# **D850GB Desktop Board Specification Update**

Release Date: November 2000

Order Number: A47761-001

**Figure 1. Audio Connectors**

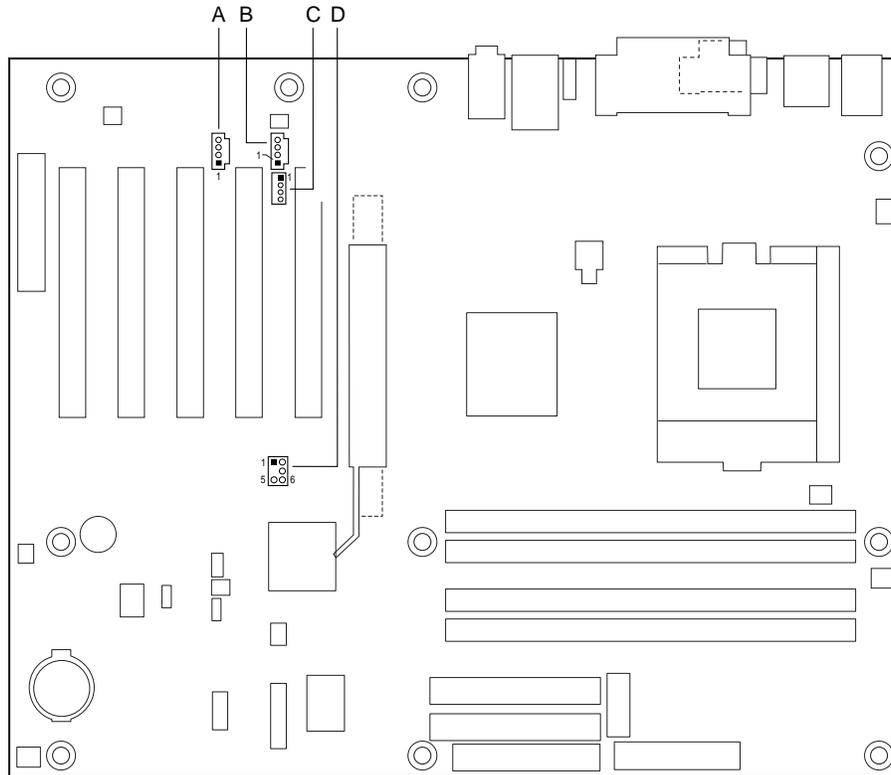
### 3. Change to Description of Section 2.8.2.2, Audio Connectors

Figure 9, Section 2.8.2.2, Audio Connectors will be changed in its entirety as follows:
